This Carolina Thomas Bus Buzz informs you of a Thomas Product Service Bulletin C2-12 Bulletin 13.

SUBJECT: CHASSIS PDM POWER CABLE CHAFING

INDEX: C2 12

BULLETIN: 13

FIGURE 1

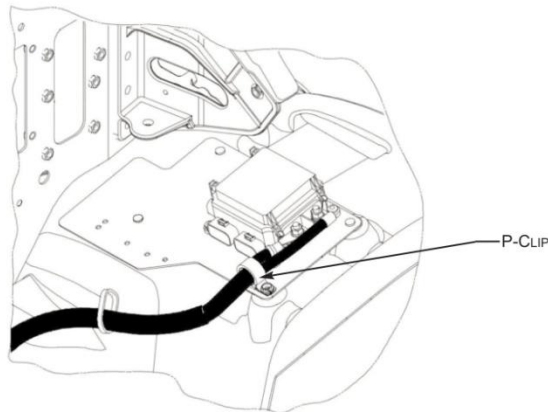
Inspection: Check the unit for the presence of a P-Clip as shown in Figure 1. If P-Clip is present, no further action is required.

FIGURE 4

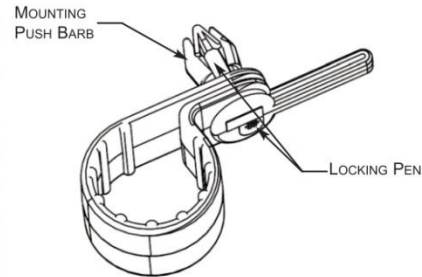
7. Locate the unused hole in the PDM mounting plate close to the power cable. **Figure 3**
8. Open the P-Clip (TBB 61480924) and install around the chassis PDM power cable that is closest to the unused hole. **Figure 4**
